Recall Bulletin

SUBJECT: Power Lift Gate Prop Rod Recovery

MODELS: 2008-2012 Buick Enclave
2009-2012 Chevrolet Traverse
2007-2012 GMC Acadia
2007-2010 Saturn Outlook
Built Prior to March 10, 2012 Equipped with Power Lift Gate (TB5 or E61)

Lift Gate Strut Orientation

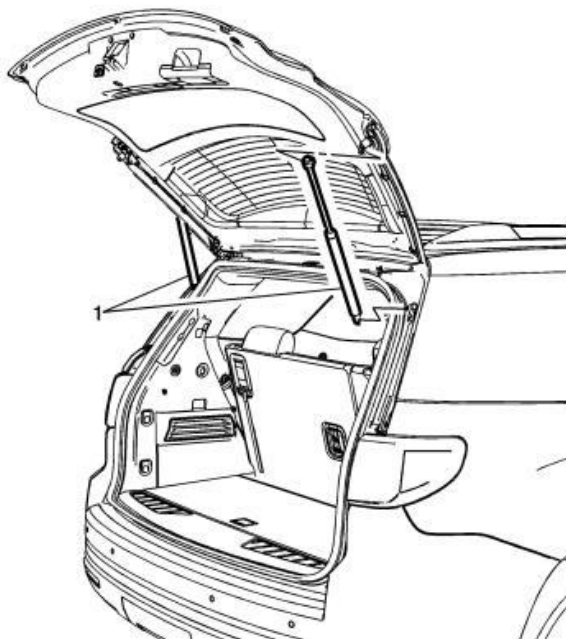
Note: GM engineering has determined that improved durability of the lift gate strut can be realized by installing the strut assembly with the rod end facing downward (attached to the lift gate) when the lift gate is in the closed position. In this orientation, dust and dirt does not collect on the strut housing to rod seal, which can cause wear on the seal.

Note: When replacing or repositioning the lift gate struts, install the strut assembly with the strut body end attached to the vehicle body and the rod side attached to the lift gate (1).
